**Site inspection Report Maxem
Original Application No. 97/2019 (WZ)**

25th September, 2021

Pursuant to the site inspection notice No. GCZMA/NGTMATTER/OApplInp-97/2019/20-21/06/933 dated 22/09/2021. The undersigned along with Mr. Devendra Gaonkar, Field Surveyor GCZMA visited the site to carry out site inspection.

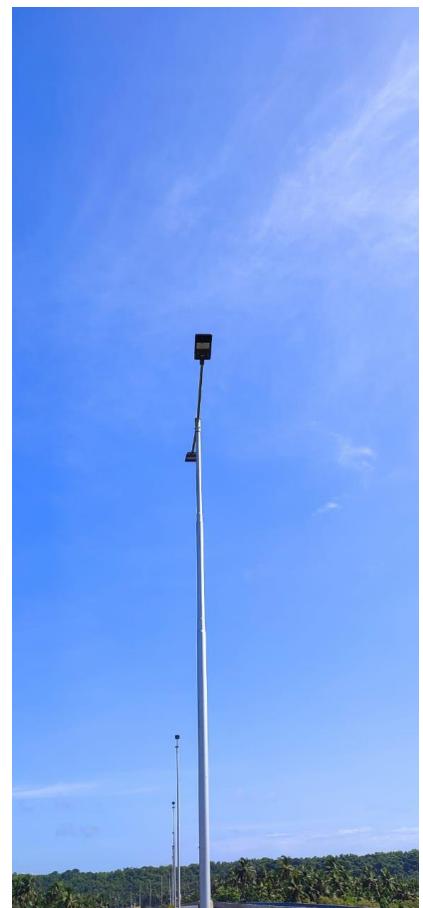
2. Earth filling in Maxem creek: Mud filling exists under the Maxem Bridge.

2. The mud deposited under the Maxem bridge has been compacted and is serving as a protection wall to the life and properties on the landward side from the tidal effect. At the time of inspection, the villagers residing there informed the undersigned that the mud is helping them as a protection barrier from the tidal influence and also from ingress of saltwater. They also informed that the matter of mud removal is in the Hon. High Court of Bombay at Goa.

3. Removal of mud from Galgibaga River and beneath the Maxem bridge must be done after a detailed scientific assessment by an expert institution. This is because, the sediment movement within the given stretch is dynamic in nature as it is constantly influenced by the intervals of low tide and high tide. Otherwise, it may have consequential ecological impact of getting other areas either eroded or accreted.
